**AGENDA**  
**CITY OF HALF MOON BAY**  
**ARCHITECTURAL ADVISORY COMMITTEE (AAC) MEETING**

- IV. **COMMITTEE MEETING ITEMS**
  - a. **PROJECT:** New Residence Resubmittal  
**CITY FILE #:** PDP-20-030  
**LOCATION:** 2778 Pullman Avenue  
**OWNER/APPLICANT:** Mark Stoloski

- b. **PROJECT:** Major Remodel and Use Conversion of an Existing Building on Main Street  
**LOCATION:** 727 Main Street  
**OWNER/APPLICANT:** Marianna Stark

**DRAFT MEETING SUMMARY NOTES  
CITY OF HALF MOON BAY ARCHITECTURAL ADVISORY COMMITTEE  
THURSDAY, APRIL 15, 2021  
ALL REMOTE/VIRTUAL MEETING VIA ZOOM**

**LOWER FLOOR PLAN**  
SCALE: 1/4" = 1'-0"

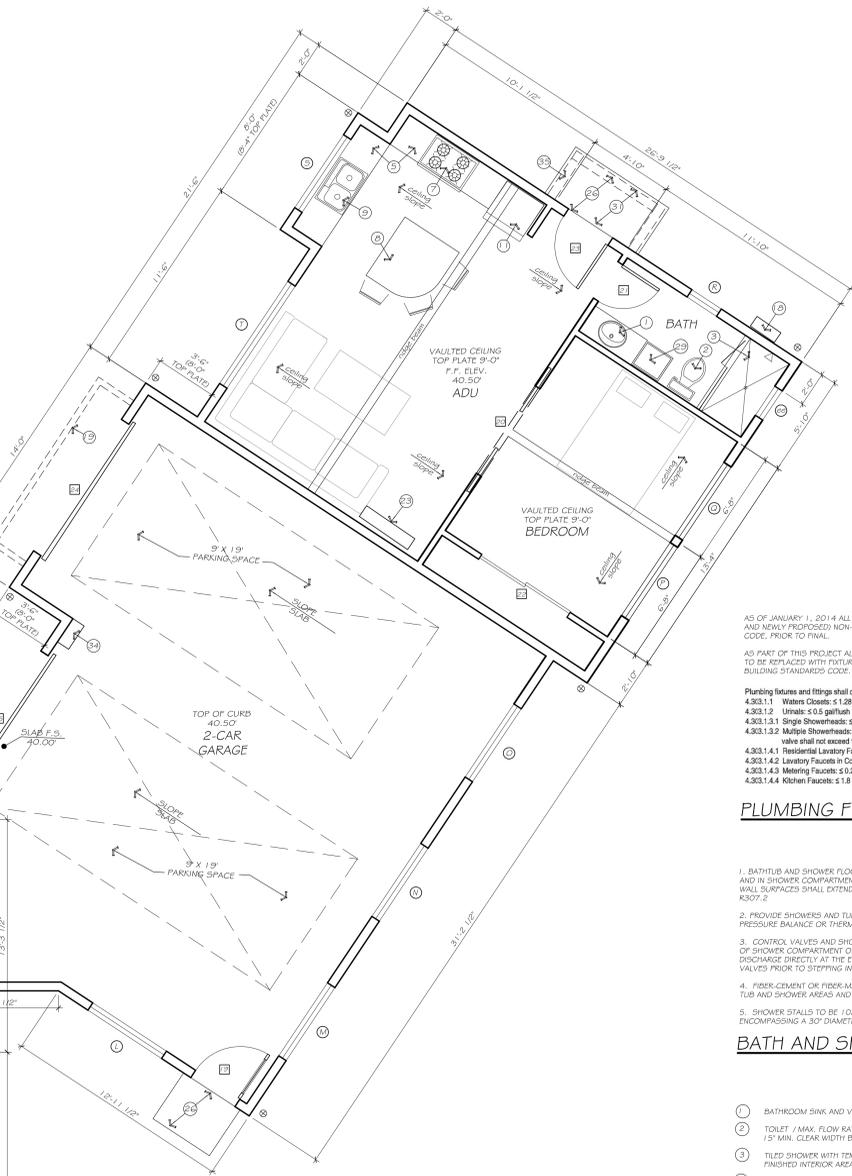
- Floor plan suggestions –
    - ADU – This is a nice 1 BR ADU, but it lacks a laundry space; suggest reducing closet space and adding a stacked W/D.
    - Bedrooms with shared bathroom – could make two separate bathrooms.

EXTERIOR PERSPECTIVES

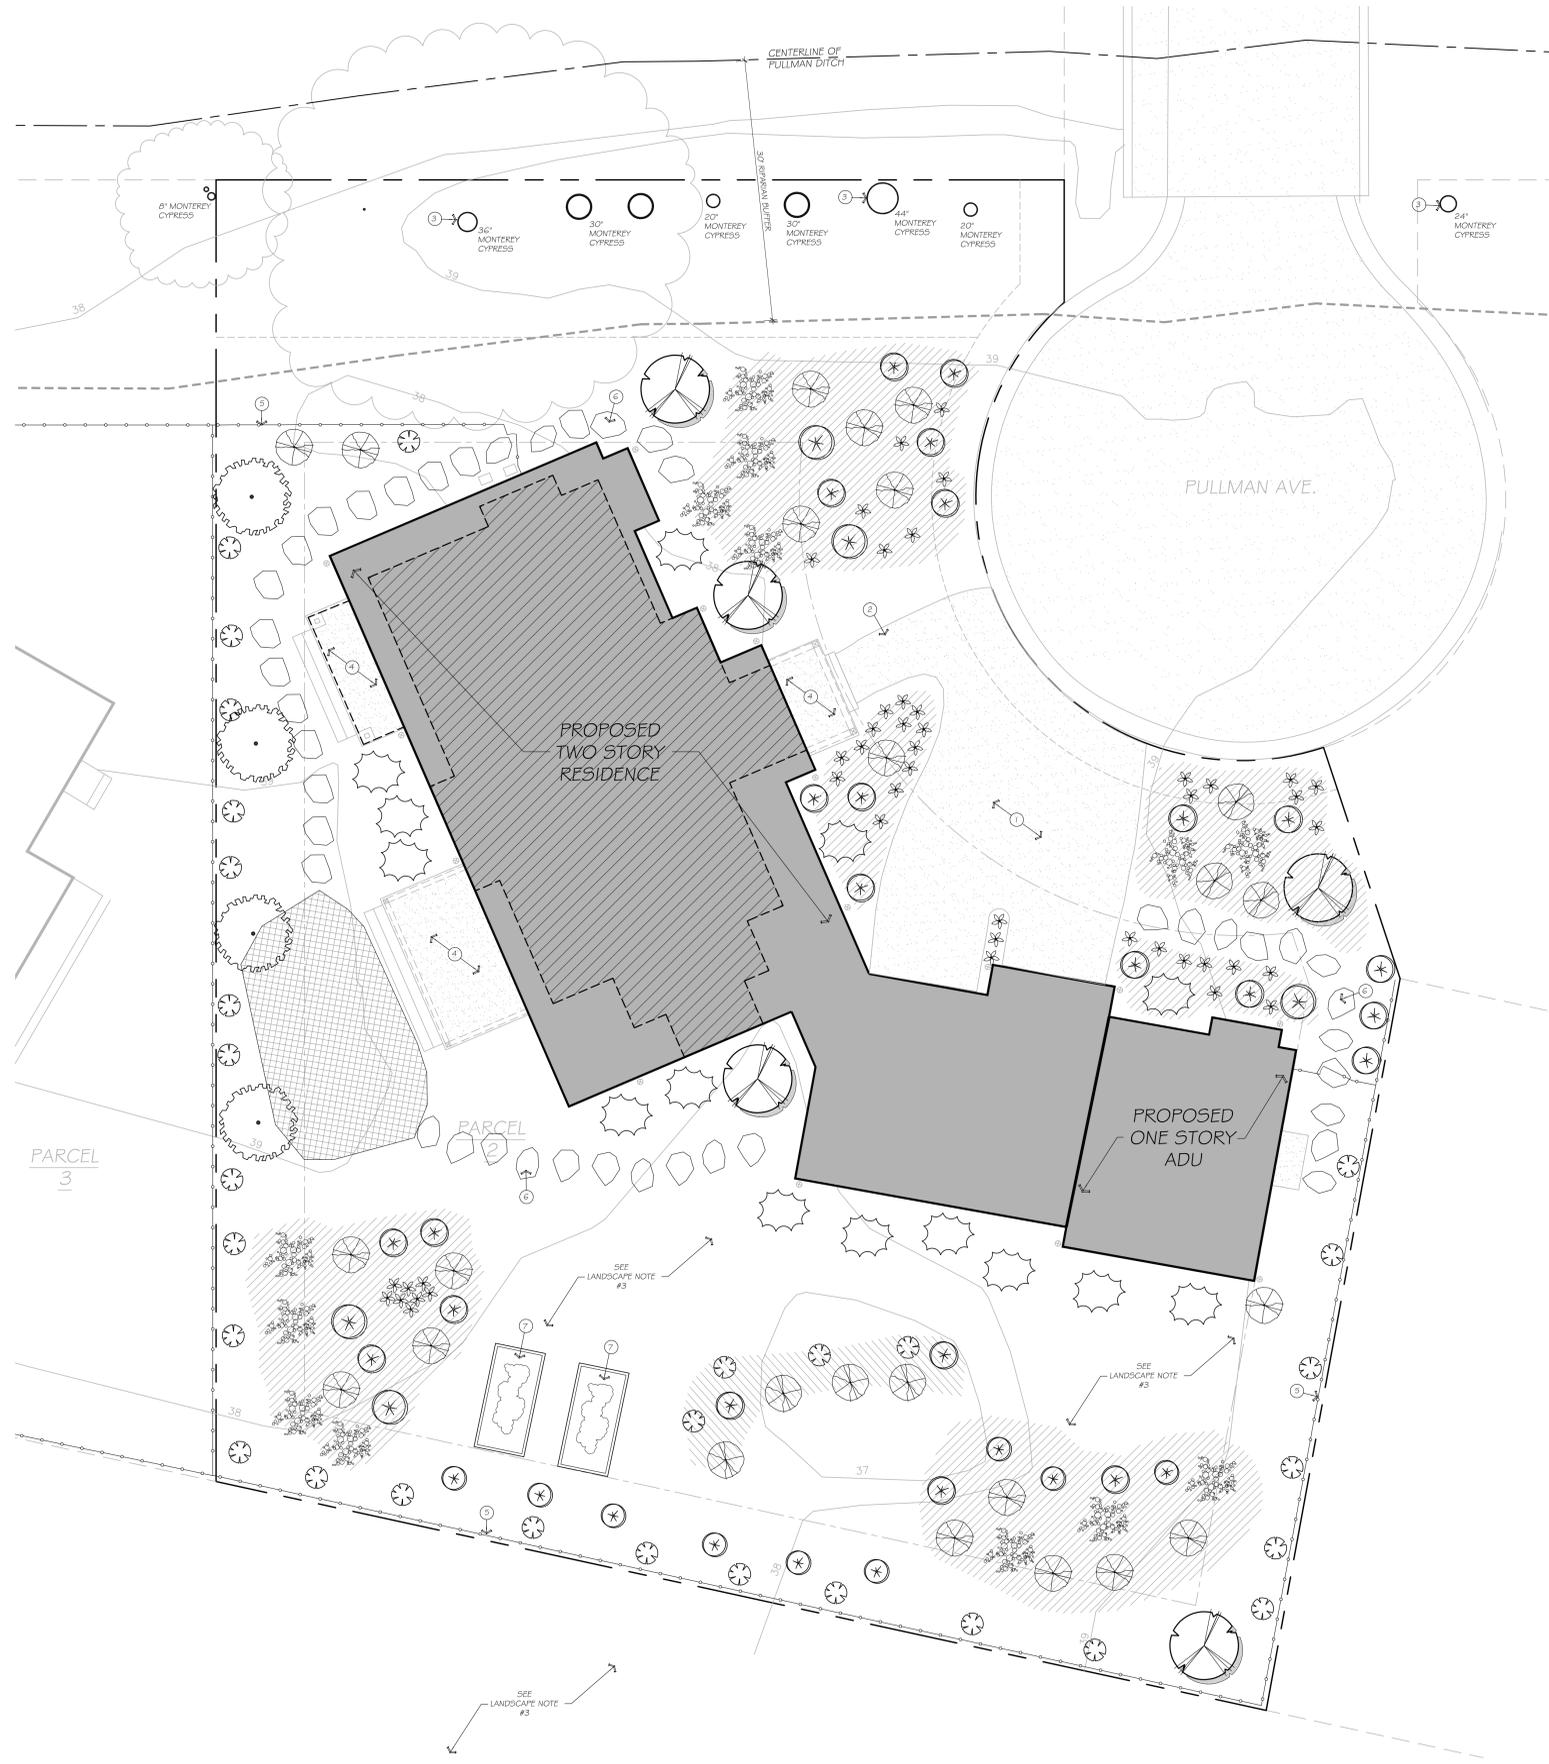
corridor. As seen on the photo rendering (Sheet A2.0 of Attachment 1), the proposed building height has been reduced to 14 feet 6 inches but has the potential to obstruct a small portion of an ocean view from Highway 1. In order to assist with evaluation of the revised proposal as it relates to the Highway 1 scenic corridor, story poles were installed on May 11<sup>th</sup>. The updated Land Use Plan brings forward the visual resource designation for broad ocean views from Cabrillo Highway as a scenic corridor (Policy 9-1 of Attachment 4). Visual resource standards for this area require 15-foot height limits unless impacts are avoided (Policy 9-15 of Attachment 4).

FIGURE 9-1: SCENIC & VISUAL RESOURCE AREAS (VRAS)

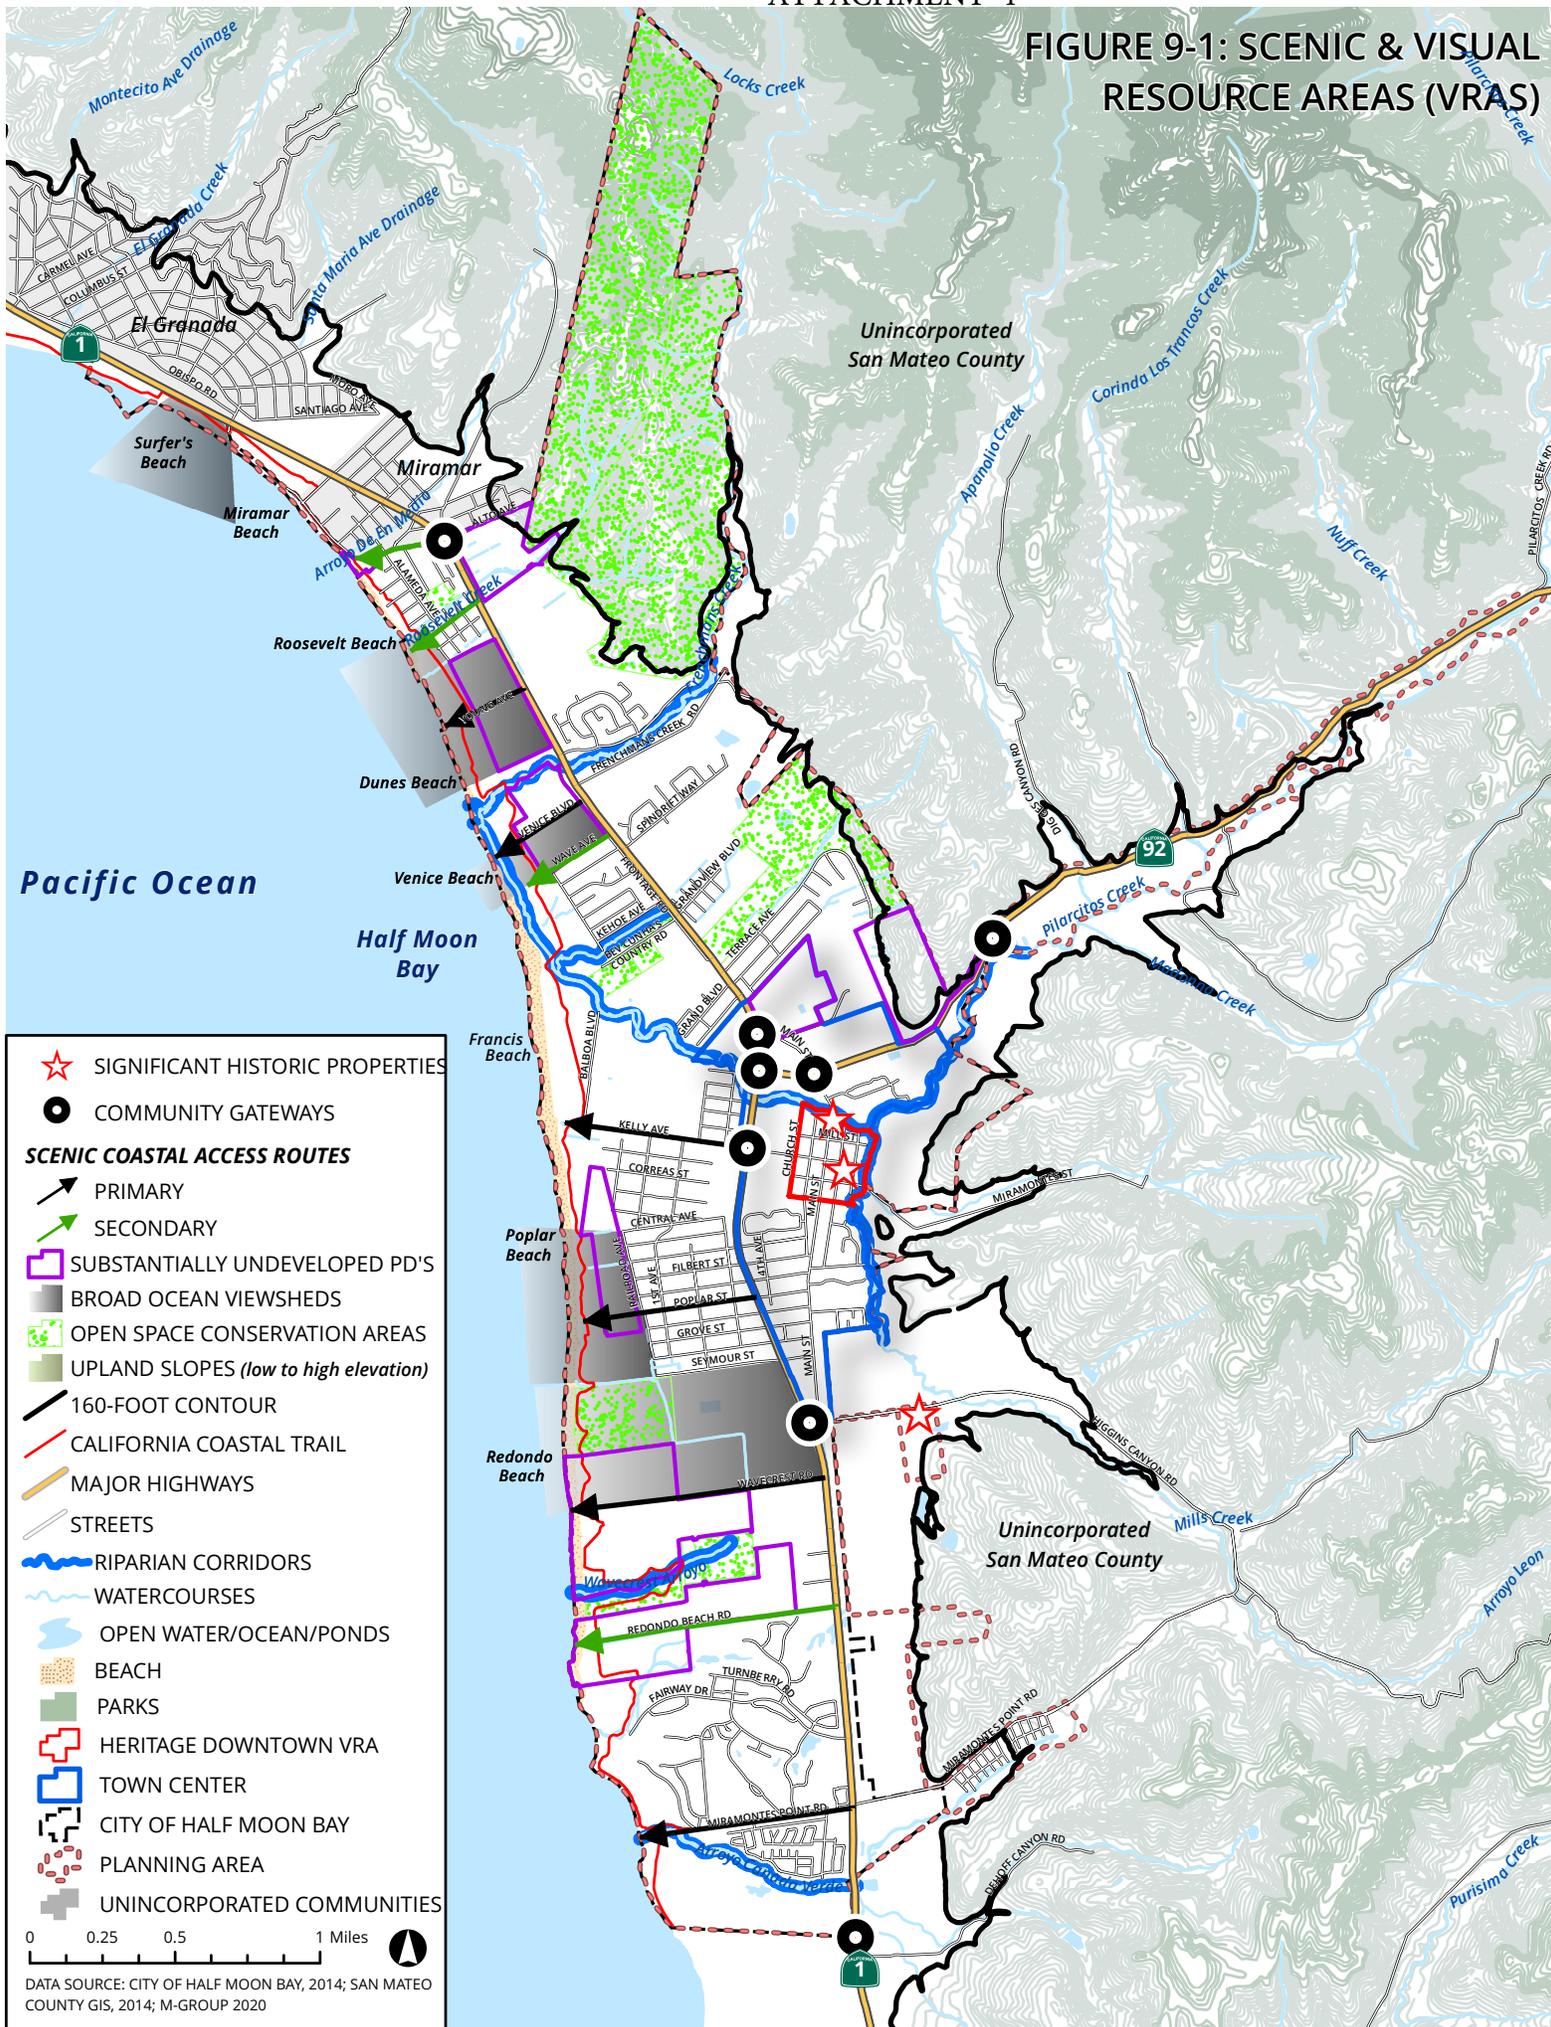
Feedback from the AAC on compliance with the Scenic Corridor Standards is of particular interest. Within the recently adopted Local Coastal Land Use Plan, Policy 9-16 provides guidance on broad public ocean views and references the map in Figure 9-1. Policy 9-16 is included in Attachment 4.
